HISTORIC PRESERVATION BOARD

HISTORIC PRESERVATION BOARD MEETING

**STAFF MEMORANDUM
HISTORIC PRESERVATION PROGRAM
PLANNING AND URBAN DEVELOPMENT**

TO: Chair Pollard and Members of the Historic Preservation Board
FROM: Rob Wiener, Historic Preservation Compliance Coordinator
DATE: October 14, 2022
RE: 99 Capisic Street, Addition and New Garage / Guest House - PUBLIC HEARING
PROJECT ID: HPBR-002024-2022
MEETING: October 19, 2022

⑤ ENLARGED PLAN - FRONT PORCH
3/4" = 1'-0"

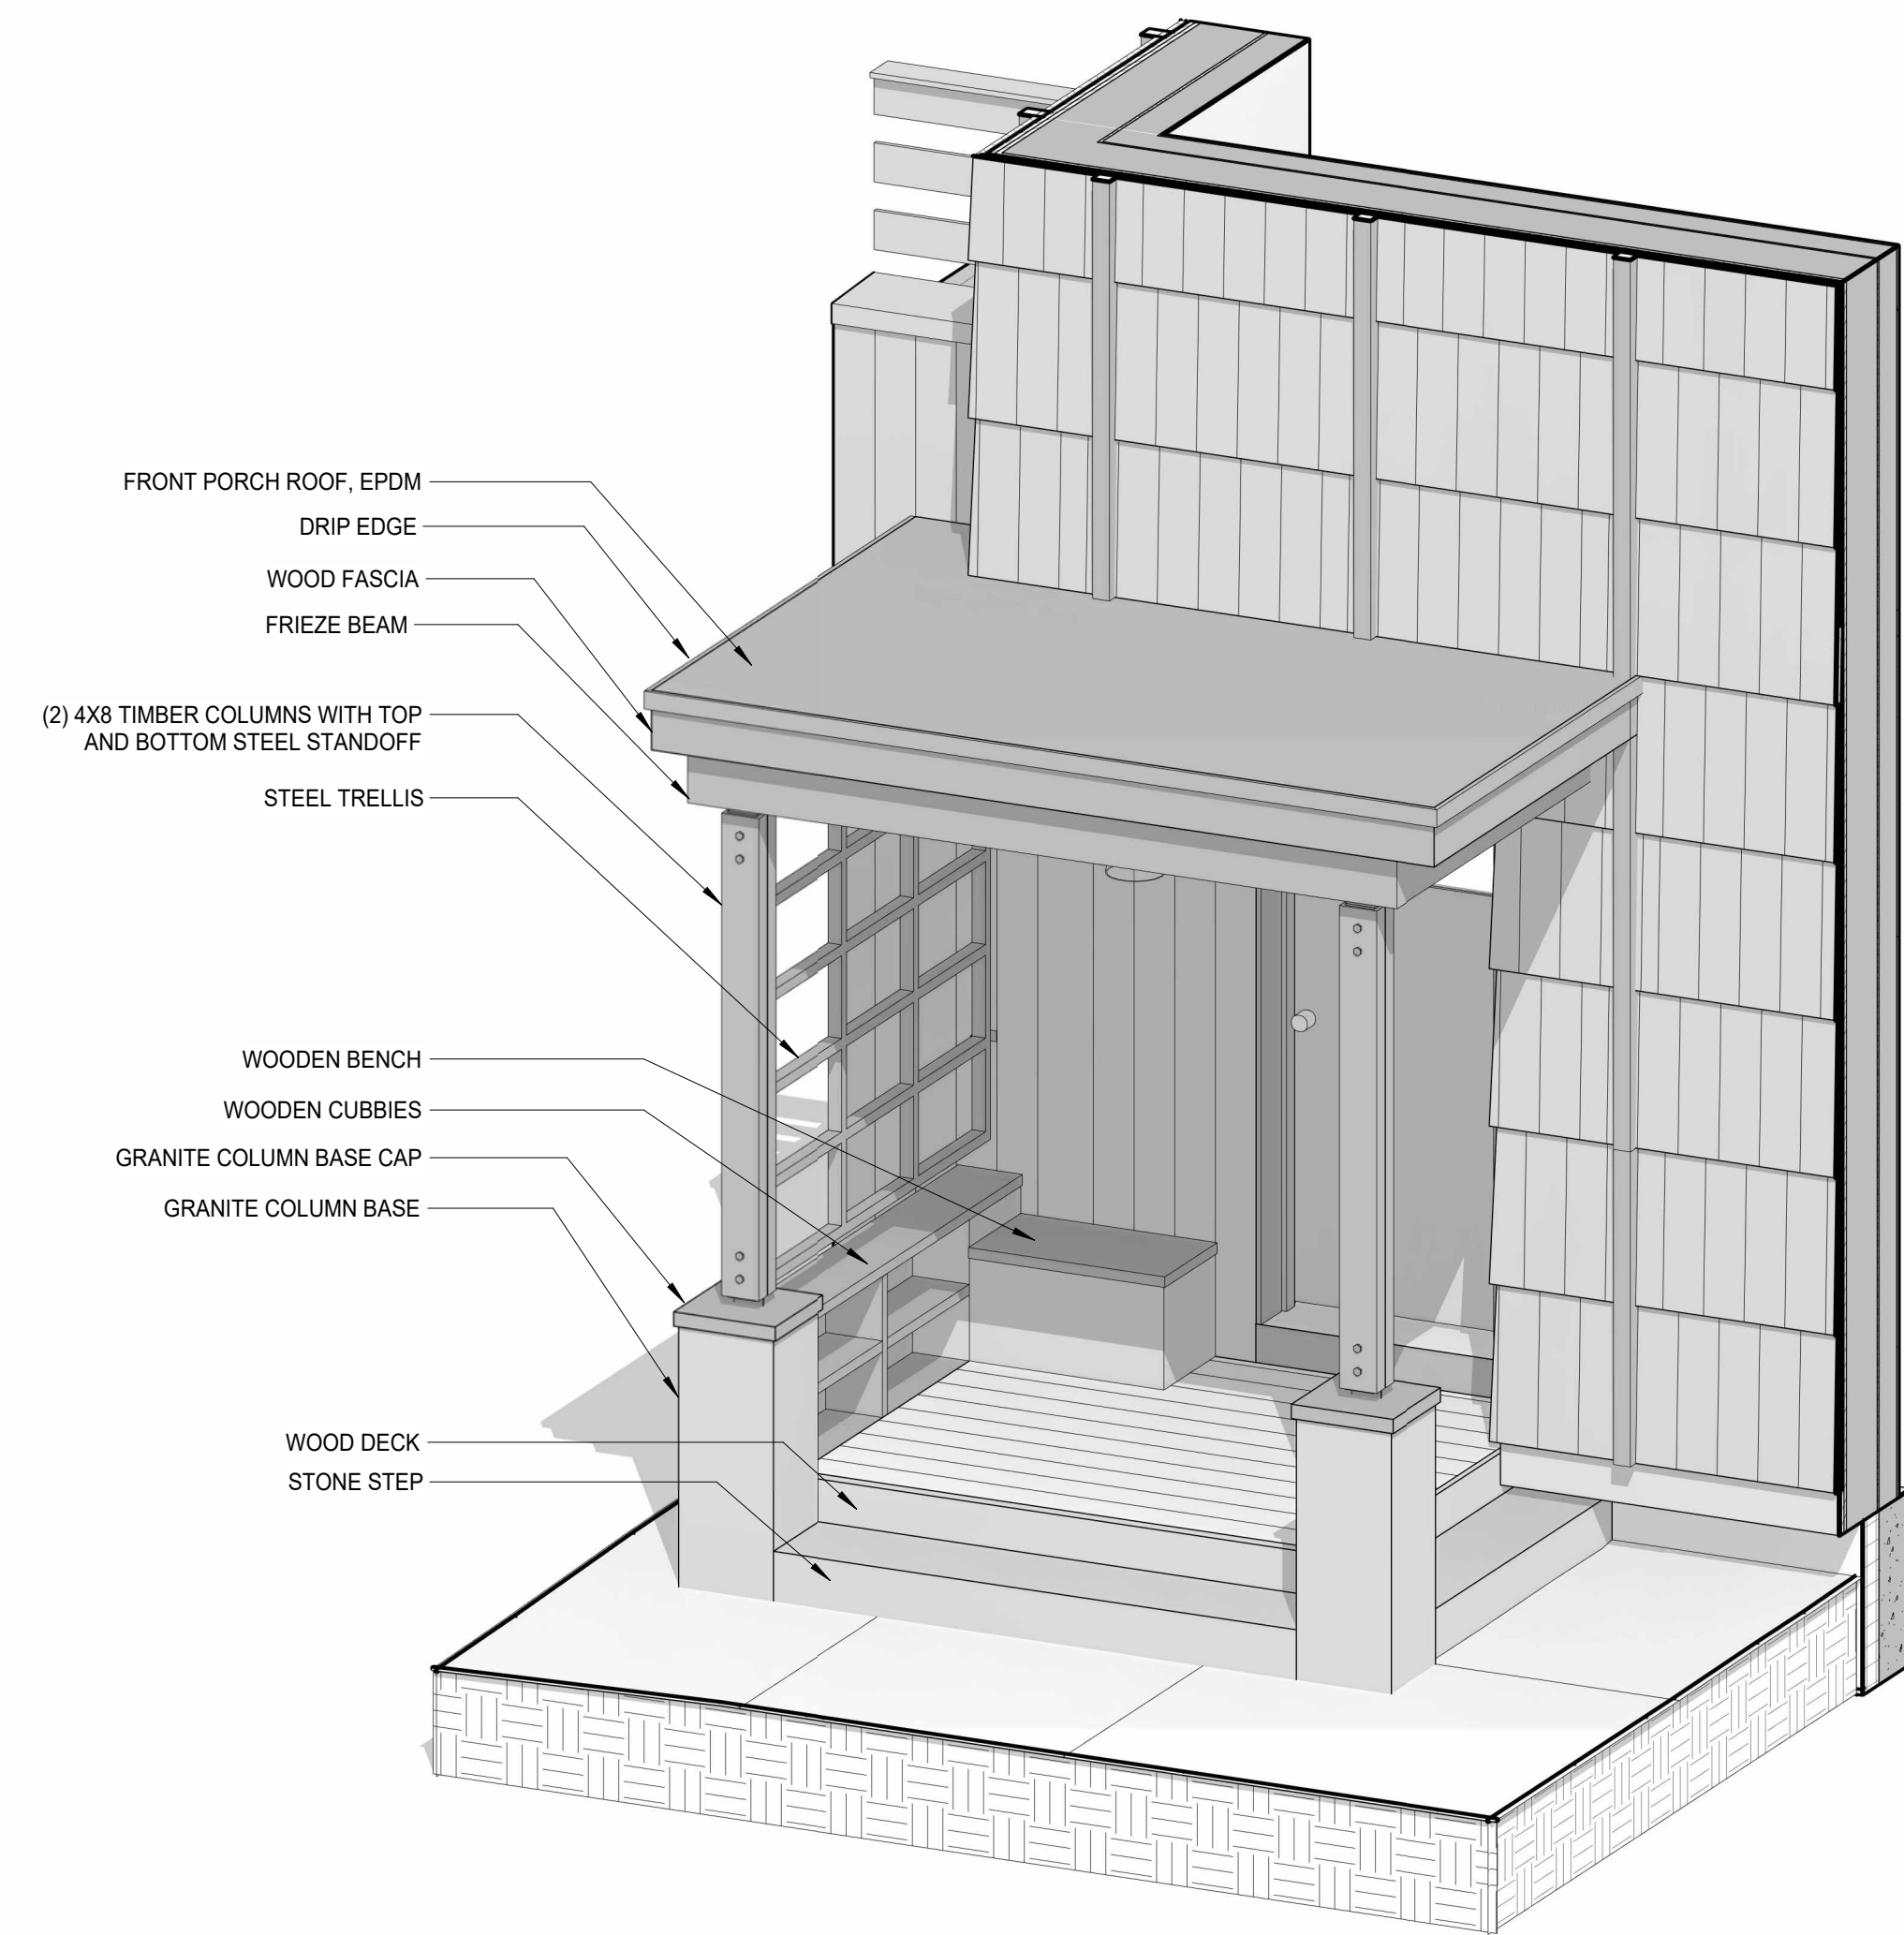
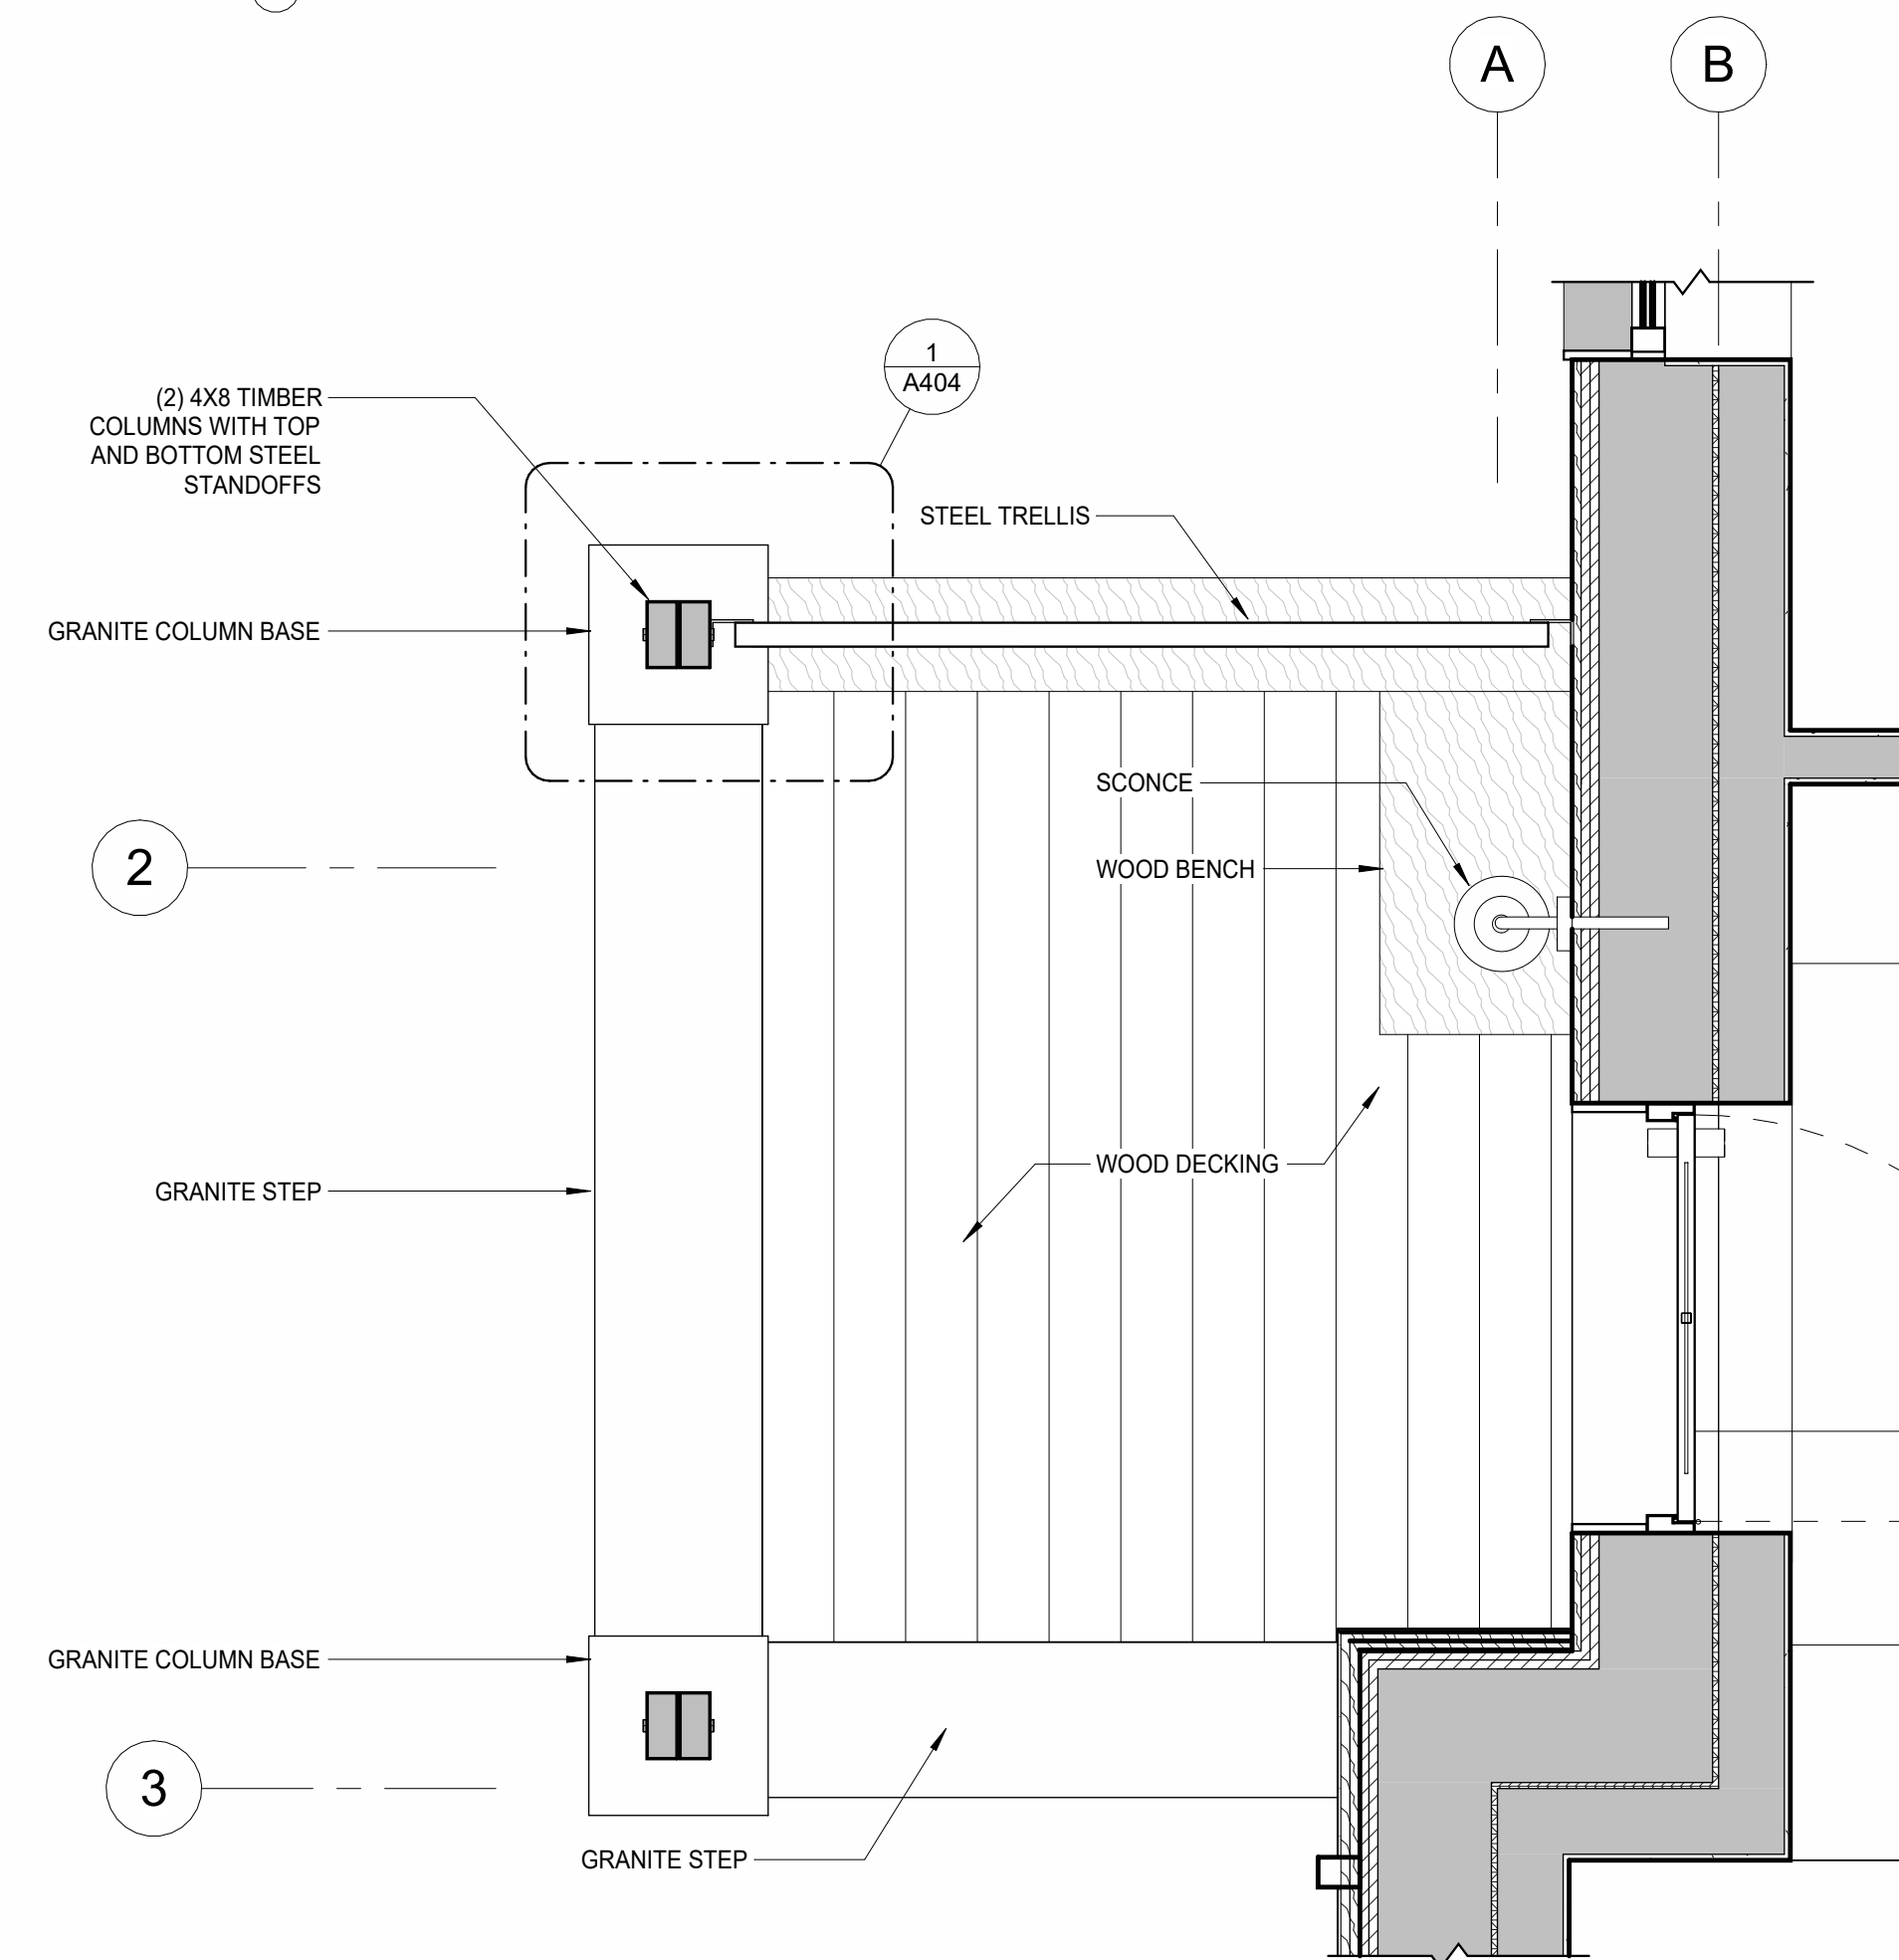
The front porch has also been redesigned to have a more symmetrical appearance and simplified support system reminiscent of the many classically inspired porches found throughout the district. The more complicated exposed structural members presented at the second workshop have been eliminated in favor of matching wood posts with metal offset caps and bases that support a simplified entablature with frieze and fascia. The posts rest on granite bases with granite caps. The applicant has also added some small cubbies, a seat, and a trellis to the porch. These elements do add some additional complexity to the porch, but this will not be readily perceptible given they are scaled comfortably to the porch and sit within its footprint, aligning with the piers and columns.
